# Access Compliance Report

## Public Rights-of-Way

### (Curb Ramps)

Intersection ID: 10020593	Main Street: BASIE_PARK_CT	Cross Street: N/A	Location: S
ADA ID: C01C2F6809F3	Ramp Type: Perp	Initial Pass/Fail: Fail	Overall Compliance: No
Severity Score: 10			
Codes/Mitigation Info/Possible Solution		Field Measurements/Component Compliance

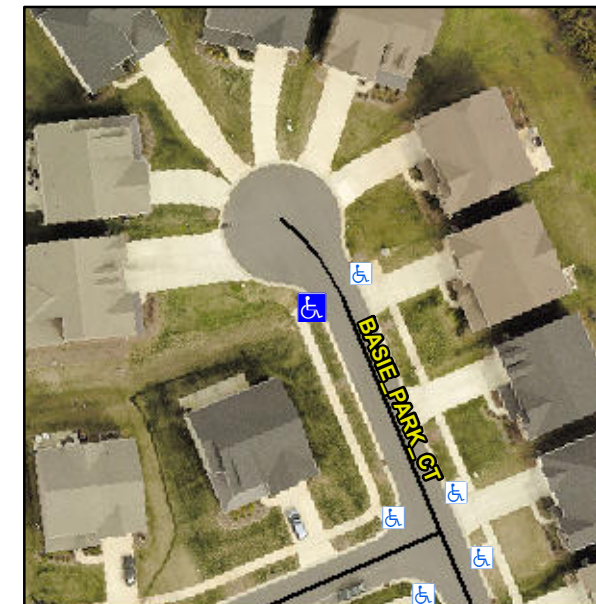
**R304.5.1, R304.5.3**

Compliance	Description	Data	Compliance	Description	Data
N/A	Ramp Length (in)	96.0	Yes	Ramp Slope (%)	6.4
No	Ramp Width (in)	39.0	No	Ramp XSlope (%)	3.4
N/A	Flare Type LT	N/A	N/A	Flare Type RT	N/A
N/A	Flare Slope LT (%)	N/A	N/A	Flare Slope RT (%)	N/A
N/A	Flare Traversable LT?	N/A	N/A	Flare Traversable RT?	N/A
N/A	Landing Length (in)	N/A	N/A	DWS Provided?	N/A
N/A	Landing Width (in)	N/A	N/A	DWS Contrast?	N/A
N/A	Landing Slope (%)	N/A	N/A	DWS Length (in)	N/A
N/A	Landing X Slope (%)	N/A	N/A	DWS Full Width?	N/A
N/A	Landing Curb? (Y/N)	N/A	N/A	DWS Offset (in)	N/A
N/A	Shared Landing?	N/A			
N/A	Gutter Ponding?	N/A	N/A	Gutter Slope (%)	N/A
N/A	Gutter Lip Ht (in)	N/A	N/A	Gutter X Slope (%)	N/A
N/A	Painted X Walk1?	No	N/A	Painted X Walk2?	N/A
	X Walk 1 Direction	To NE		X Walk 2 Direction	N/A
N/A	X Walk 1 Width (in)	N/A	N/A	X Walk 2 Width (in)	N/A
	X Walk 1 Slope (%)	3.5		X Walk 2 Slope (%)	N/A
	X Walk 1 X Slope (%)	2.5		X Walk 2 X Slope (%)	N/A

**Remove & Replace Entire Ramp.**
